S E R V I C E N O T E

HP 8566B Spectrum Analyzer
 HP 8567A Spectrum Analyzer
 HP 8568B Spectrum Analyzer
 HP 85662A IF-Display Section

Misloaded Capacitor Exposed to 130% of Its Rating

DATE: 25 May 1990

Figure 1. Location of A1A10C1 and A1A10C4

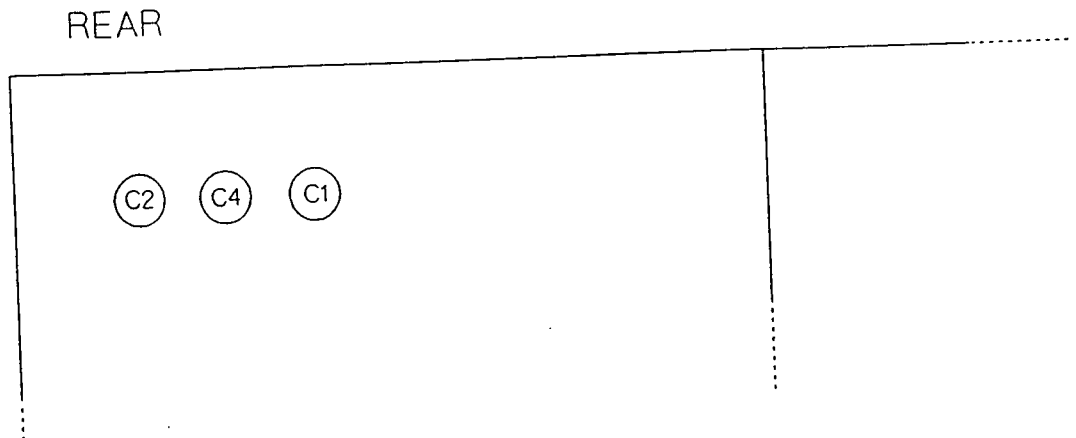
An assembly process variation was discovered that might have resulted in two large electrolytic power supply capacitors being installed in the wrong location in HP 85662A IF-Display Sections within the serial range listed above. When installed in the wrong location, one of the capacitors can be exposed to as much as 130% of its rating. This would probably result in a premature capacitor failure, with possible venting of the capacitor electrolyte onto the bottom of the IF-Display Section. Venting might cause damage to other components and assemblies.

The two capacitors affected are A1A10C1, 22000 μ F (HP part number 0180-2808), and A1A10C4, 8700 μ F (HP part number 0180-0453). They are located along the HP 85662A rear frame, behind the CRT. Both capacitors are the same physical size.

1. Remove the power cords and interconnect cables from the rear of the spectrum analyzer.
2. Loosen the lock feet and separate the RF and the IF sections; set the RF section aside.
3. Remove the 2 rear feet near the top of the IF-Display Section.
4. Remove the top cover and check for proper position of the capacitors (A1A10C1 and A1A10C4). See Figure 1.

Any HP 85662A IF-Display Section within the above serial range should be inspected. If capacitors A1A10C1 and A1A10C4 are found to be installed in the wrong location, replace both capacitors with new ones using the following procedure.

8. Remove the 4 screws securing A1A10C1 and A1A10C4 to the motherboard.
9. Remove the existing capacitors and replace with new capacitors, making sure the A1A10C1, 22000 μ F (HP part number 0180-2808), and A1A10C4, 8700 μ F (HP part number 0180-0453), are in the correct locations.
10. Reinstall the bracket, top cover, bottom cover, and the 4 rear feet.
11. Mate the IF and RF sections and reconnect cables. No calibration is required.
